D/DRC Case

1504-1516 Williams Street; 401 Hampton Street; 9 & 21 Science Alley

DESIGN/DEVELOPMENT REVIEW COMMISSION
DESIGN REVIEW DISTRICT
EVALUATION SHEET
Case #1

NATURE OF REQUEST: Request for Certificate of Design Approval for new construction. City Center Design/Development District

1 WEST ELEVATION
1/8" = 1'-0"

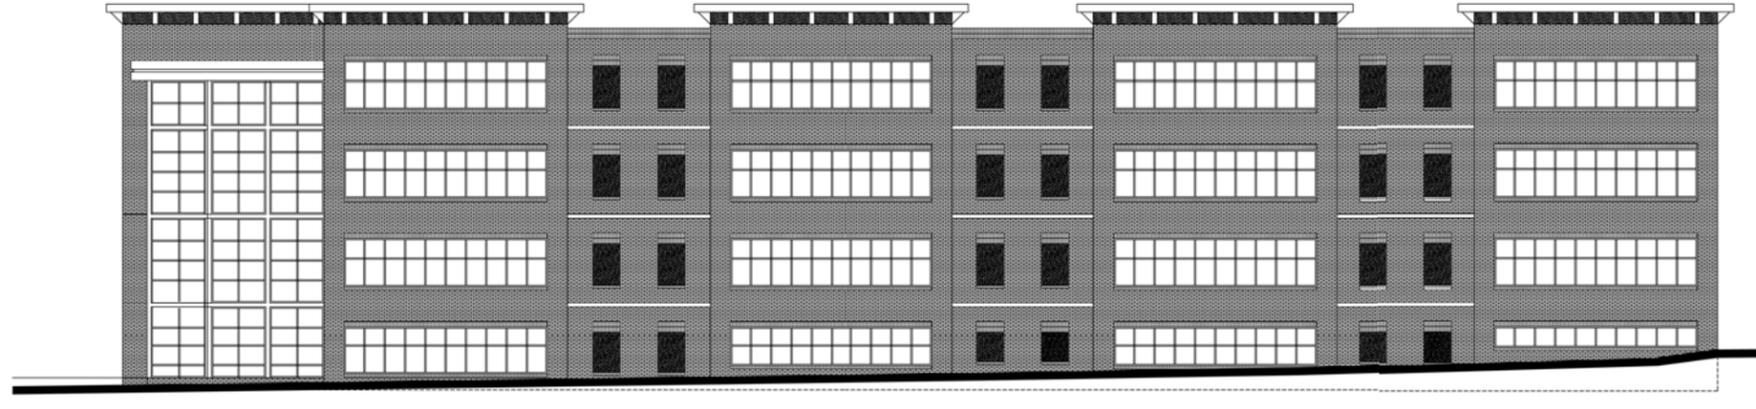
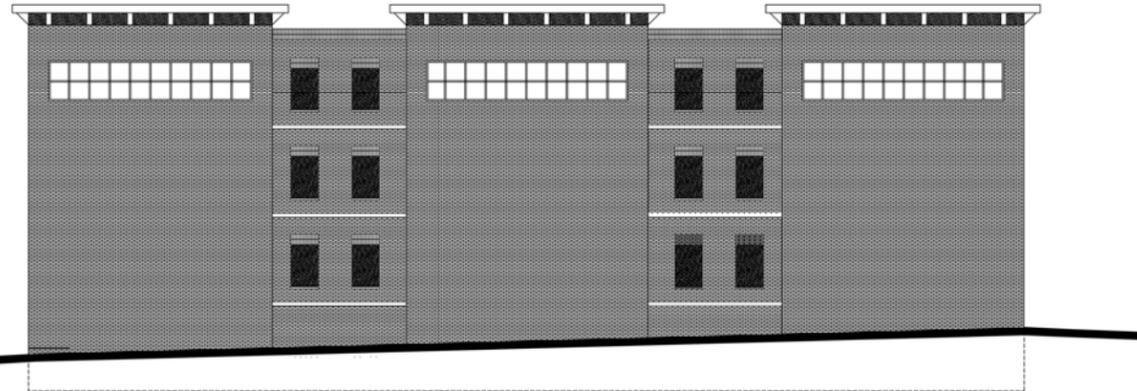
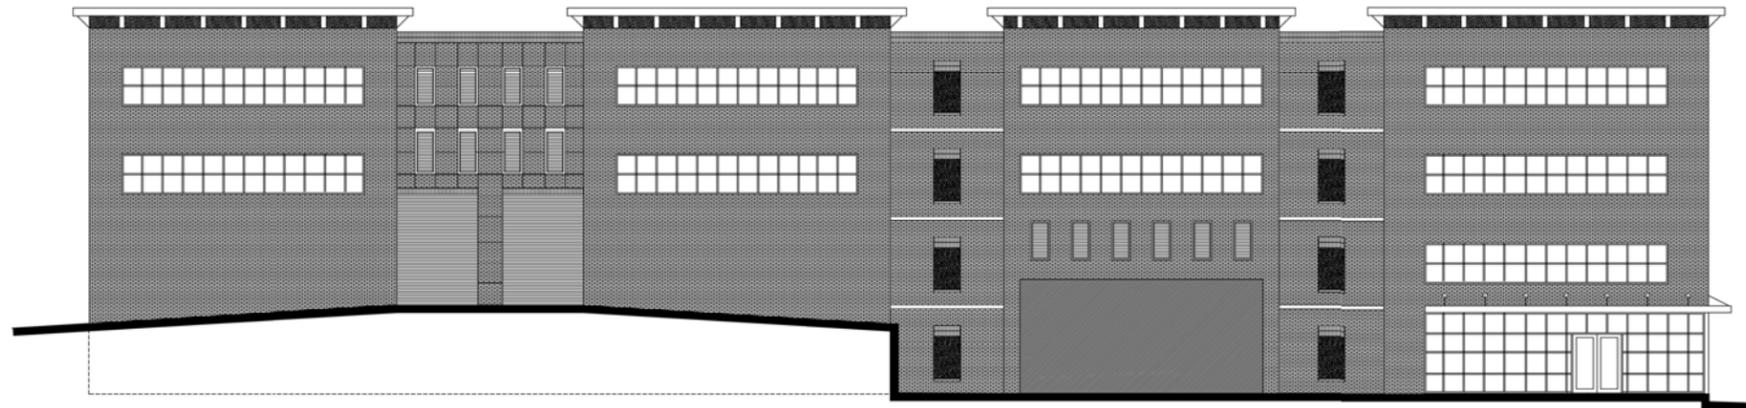
The building design is fairly straightforward, with large brick bays and rows of windows, consistent with its use as a storage warehouse. The height of the building is under the 50' allowed by the PUD zoning and appropriate for the surrounding context.

The building has been designed to orient the circulation space on the perimeter, allowing for lots of windows on the upper floors. The first floor has larger window openings which are more consistent with storefront configurations.

The building is divided into structural bays with projecting and recessed elements.

The building has large window openings on both street-facing facades. The windows are recessed to provide a reveal of 4". Cast stone detailing has been added to help articulate the windows.

The large, decorative cornice and brackets detail makes a strong statement at the top of the building.

Windows along the first floor are clear glass with a brick bulkhead.

The primary building materials of red brick with aluminum storefront are consistent with buildings in the Vista. Cast stone detailing and the parapet add contrast and articulation.

The proportions of the building's upper façade are appropriate, and the design has a distinct base, middle and top.

The cornice is prominent and adds a strong stylistic element to the building.

The wall materials and windows on the upper façade are consistent with the overall building design and add interest and articulation to the building design.

DRAWING TITLE:
PLANTING PLAN AND DETAILS

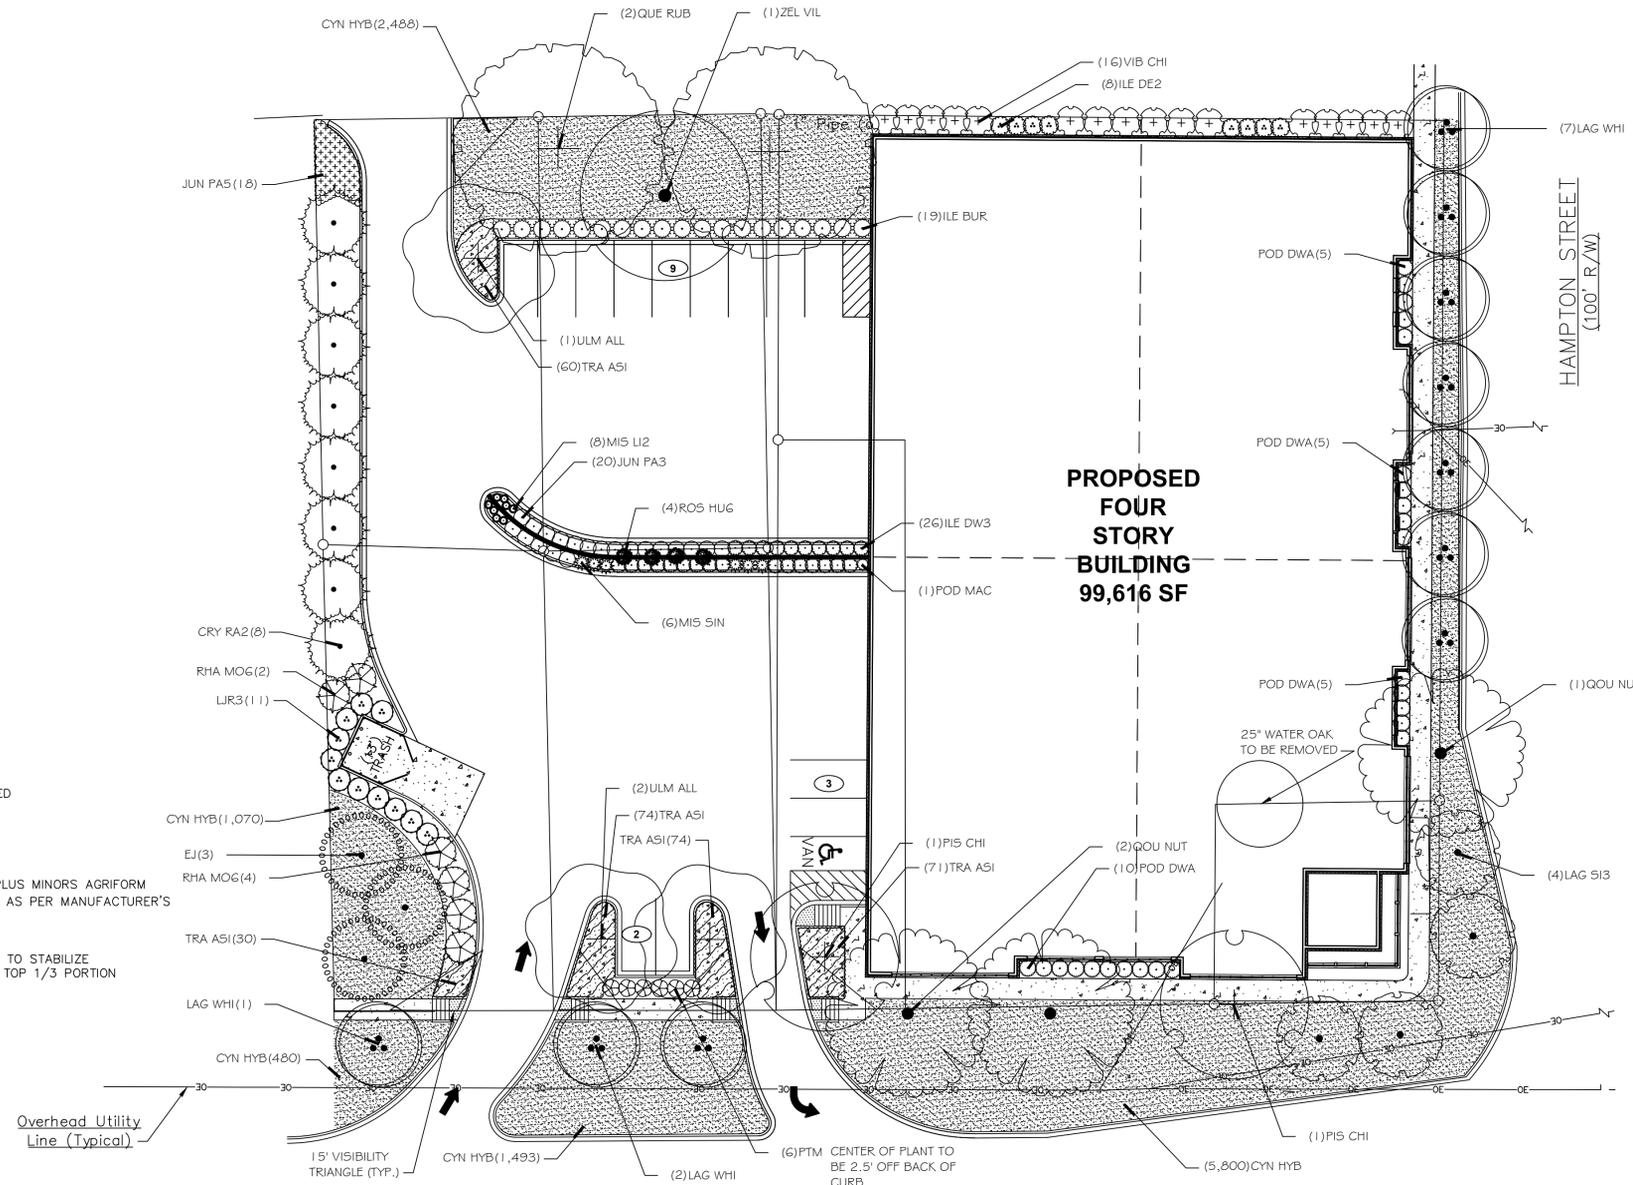
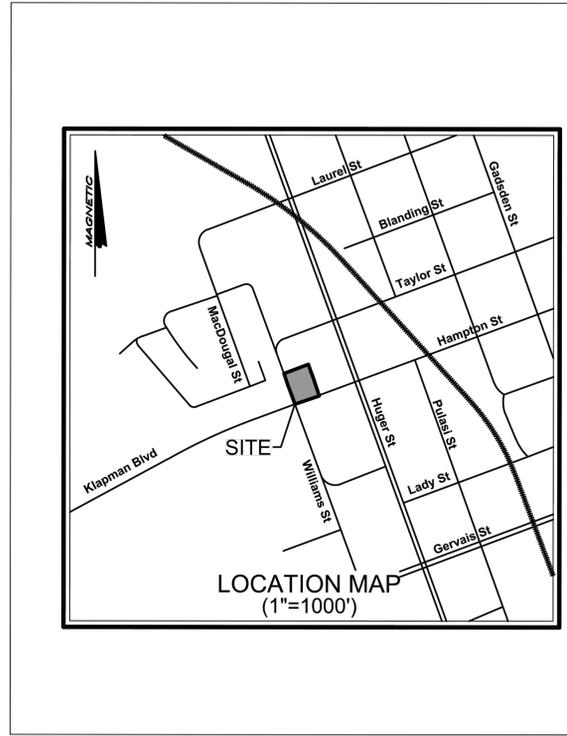
The building site will fully comply with the City's landscape ordinance. The applicant is providing trees along both Williams Street and Hampton, as well as providing a new sidewalk along both street frontages, with a landscaped buffer between the sidewalk and the curb.

The entire parking area could be considered loading due to the use of the building as a storage unit. The parking lot has been continuously screened with evergreen screen hedges on all sides that will be visible from the public right-of-way.
